Approval no: DEV2019/1001

1 April 2019
Our Ref: J6483 JH

Flood Impact Assessment – Response to Information Request 6-12 Auster Street, Redland Bay

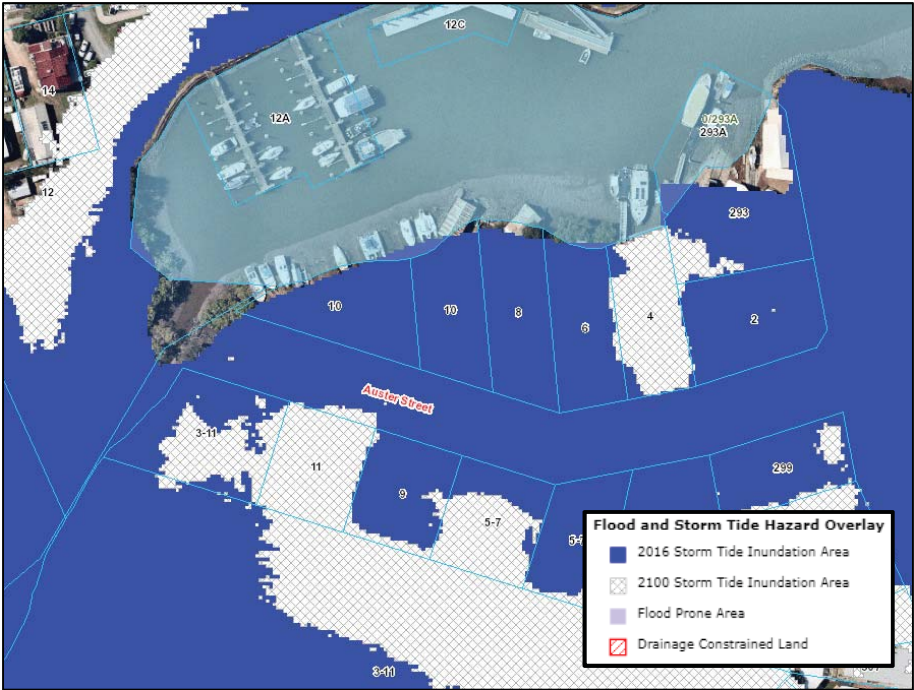
The subject site is also affected by flooding from storm tide (refer Redland City Council overlay mapping below). Storm tide flooding is the effect on coastal water levels of a storm surge combining with the normally occurring astronomical tide. Storm surge is a rise above normal water level due to the combined effects of surface wind stress and atmospheric pressure fluctuations caused by severe weather conditions such as tropical cyclones. During such events, there would be a significant amount of flood storage available along the coastline. As such, the proposed works would therefore not result in a material worsening on adjoining properties.

Figure A

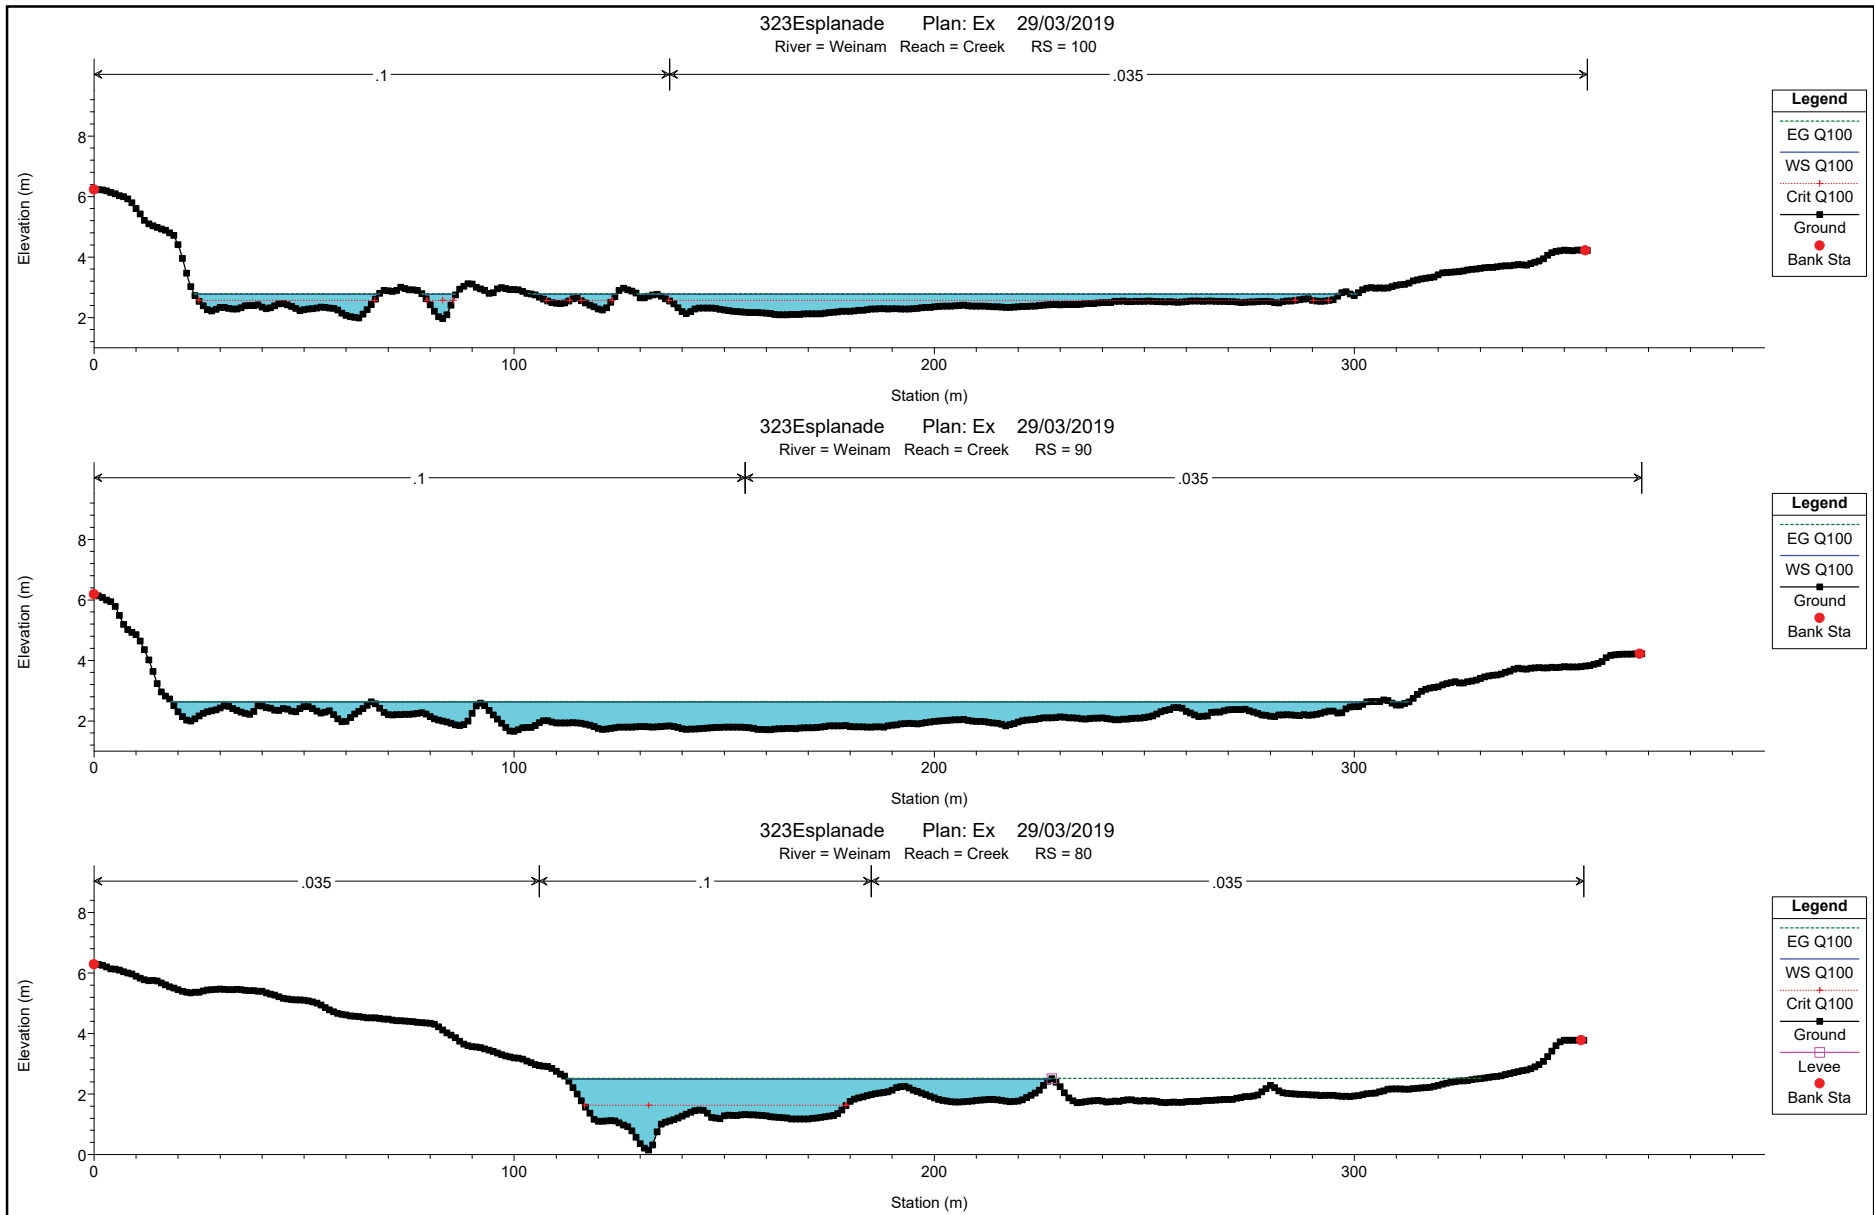
The results presented above indicate that the flood levels calculated in the HECRAS model are similar to those presented in the TUFLOW model by GHD. The 1% AEP flood extent is contained within Weinam Creek and does not exceed the creek banks (refer attached approximate 1% AEP flood extent plan). The 1% AEP flood level within the creek adjacent Auster Street is 1.53 m AHD, which is below the portions of the subject site undergoing development. As such, the proposed works would not be blocking the creek flow path and would therefore not result in a material worsening on adjoining properties.

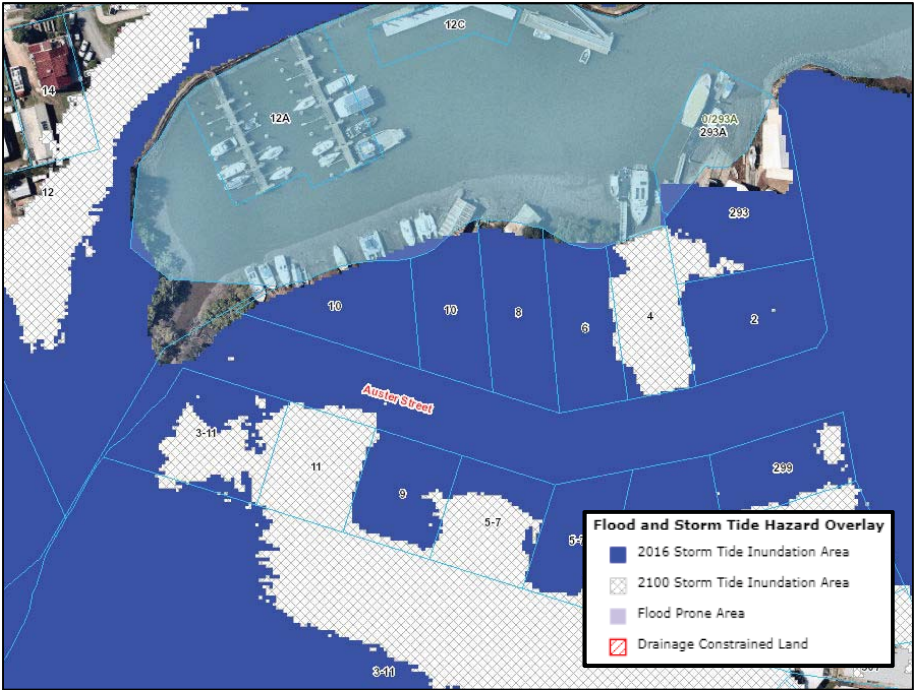
The subject site is also affected by flooding from storm tide (refer Redland City Council overlay mapping below). Storm tide flooding is the effect on coastal water levels of a storm surge combining with the normally occurring astronomical tide. Storm surge is a rise above normal water level due to the combined effects of surface wind stress and atmospheric pressure fluctuations caused by severe weather conditions such as tropical cyclones. During such events, there would be a significant amount of flood storage available along the coastline. As such, the proposed works would therefore not result in a material worsening on adjoining properties.
